**A Flood Early Warning System
And
Flood Response Plan
For the City of Fort Worth**

Final Report

**Stormwater Management Division,
Transportation and Public Works Department
City of Fort Worth**

City Response to TWDB Review Comments

Figure 8. Comparison of float switch response against water level measurement at the Bryce-Hulen detention basin for two events in 2018 (installation was completed in August, 2018). These graphs were generated in the Contrail software. The dots mark timing of reports to the receive station.

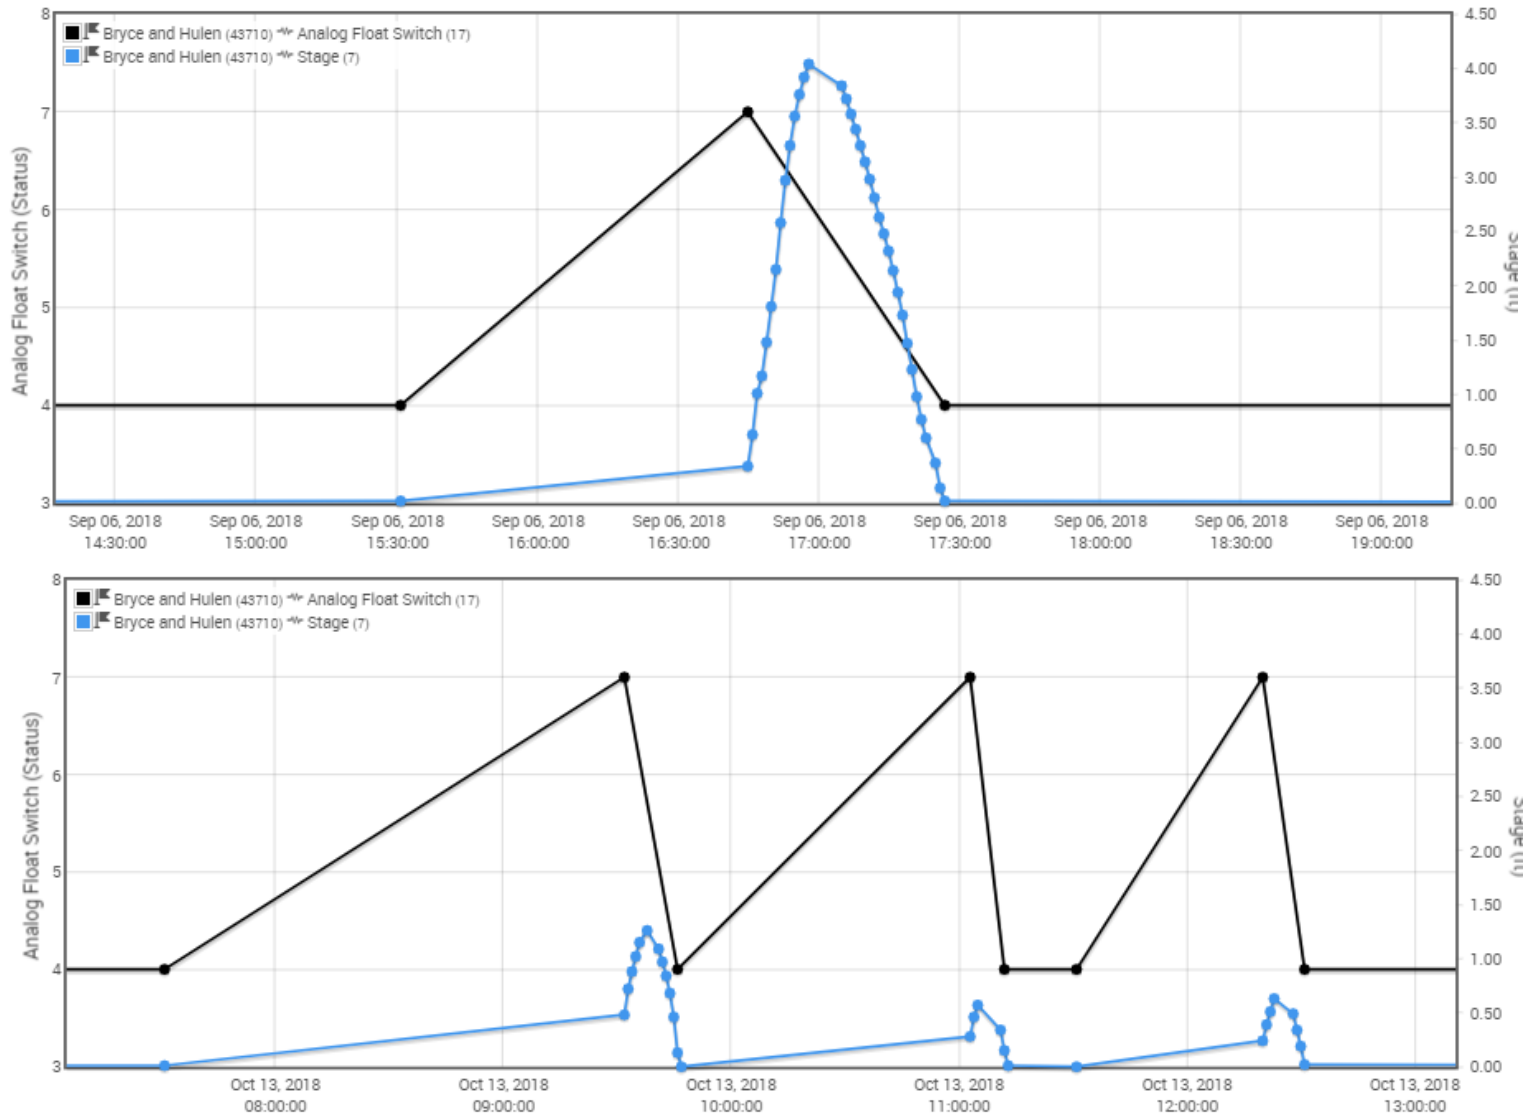
7. Page 10, Sub-Task 1.2 – Were any low water crossing sites installed? If not, please provide a statement indicating why none were installed.

City response (text added): During this grant, continuous water level measurement with a PT and float switch was tested at the Bryce-Hulen detention basin in the Central Arlington Heights (CAH) neighborhood to test flood measurement by two different sensors. The float switch provides a simple on/off trigger signal when the water level reaches a determined depth. The additional gauging with float switch was tested at the Bryce-Hulen detention basin only. Once tested, the combination (PT and float switch) gauging will be implemented by the City as separate effort.
